## PLANNING AND ZONING BOARD STAFF REPORT

### The Edge at Pineapple Grove

Meeting	File No.	Application Type
September 17, 2024	2022-008-SPF-SPR-CLV	Level 4 Site Plan
Applicant	Property Owner	Authorized Agent
Downtown Second Street, LLC	215 NE 6 <sup>th</sup> Ave, LLC	Dunay, Miskel & Backman, LLP

Provide a recommendation to the City Commission on a Level 4 Site Plan (including a Landscape Plan, Architectural Elevations, and Waiver) to construct a seven-unit townhouse development.

**April 15, 2024, PZB.**

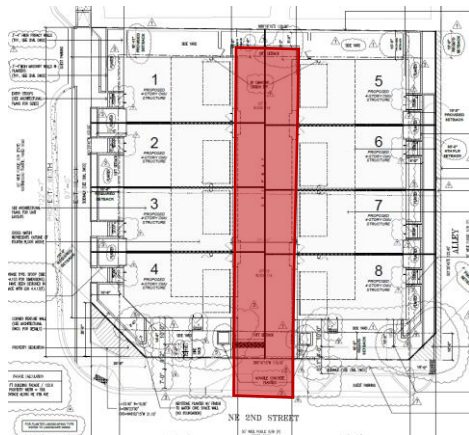
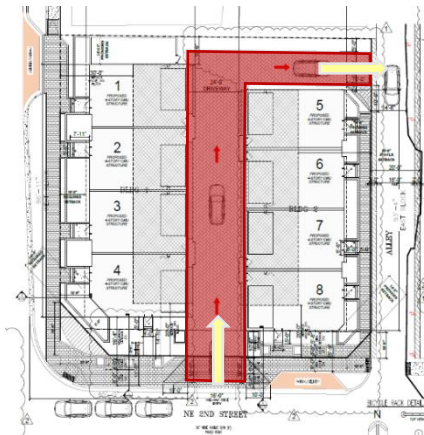
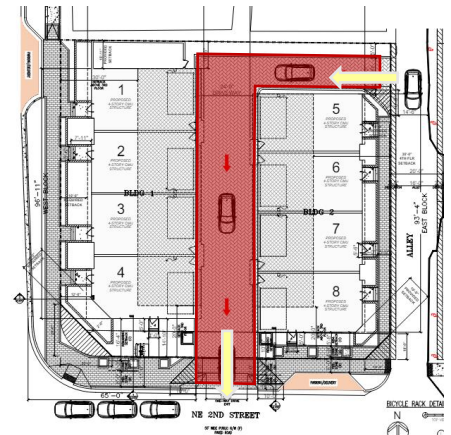
The applicant revised the vehicular access by providing sole ingress from NE 2<sup>nd</sup> Street and egress onto the alley. PZB reviewed the waiver request for vehicular access from a Primary Street and recommended approval, 5-2, with the condition that the ingress is from the alley and the egress is onto NE 2<sup>nd</sup> Street.

Voting 4-1, Commission denied the waiver request for LDR Section 4.4.13(l)(3)(b)1., to allow vehicular access from a Primary Street (NE 2<sup>nd</sup> Street), rather than the alley, which should be the primary source of vehicular access to off-street parking. The applicant has revised the configuration of the site plan to propose no vehicular access from NE 2<sup>nd</sup> Street (excluding the gate entrance for emergency vehicles) and sole ingress and egress is from the alley. The revised configuration required the removal of one unit, for a total of seven units.

**NE 2<sup>nd</sup> Street (West Block)**

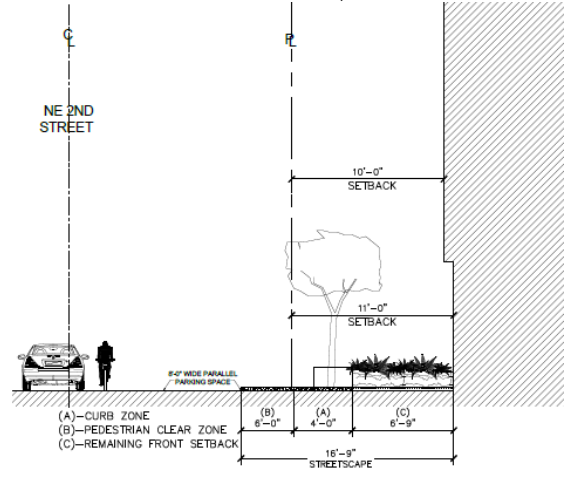
**Provided:** 16 feet, 9 inches (total)  
**Curb Zone:** 4 feet  
**Ped. Clear Zone:** 6 feet  
**Front Setback Area:** 6 feet, 9 inches

**NE 2<sup>nd</sup> Street (East Block)**

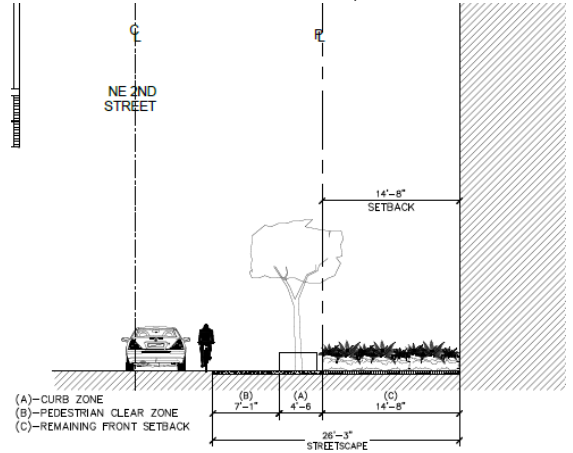
**Provided:** 26 feet, 3 inches (total)  
**Curb Zone:** 4 feet, 6 inches  
**Ped. Clear Zone:** 7 feet, 1 inch  
**Front Setback Area:** 14 feet, 8 inches

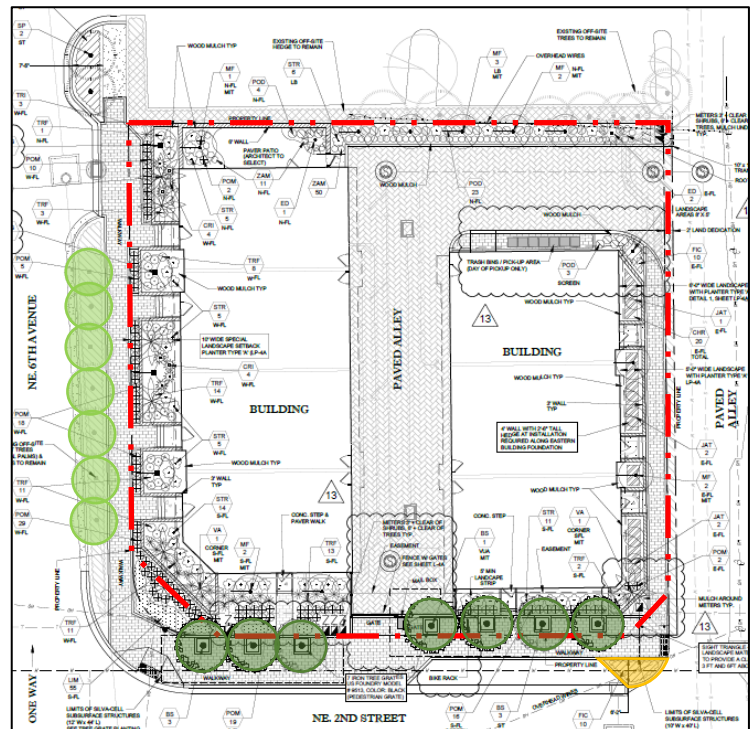
The project also includes waiver request from the requirements in **LDR Section 4.6.16(H)(3)(i)**, for relief to the required shade tree to be planted in the landscape island on the southeast corner adjacent to the parallel parking spaces along NE 2<sup>nd</sup> Street, shown in yellow.

The proposal includes three on-street parallel parking spaces, two spaces on NE 2<sup>nd</sup> Street and one space on NE 6<sup>th</sup> Avenue. The parking spaces shall be terminated by a landscape island minimum of nine feet and 135 square feet. The applicant is requesting for relief to the required shade tree as the required tree would conflict with the existing underground utilities. As the landscape is limited due to the existing watermain, the proposed landscape island will be planted with green island ficus. The request is not anticipated to negatively affect the neighboring area or create unsafe conditions. The Board should consider if the request results in an inferior pedestrian experience along NE 2<sup>nd</sup> Street.
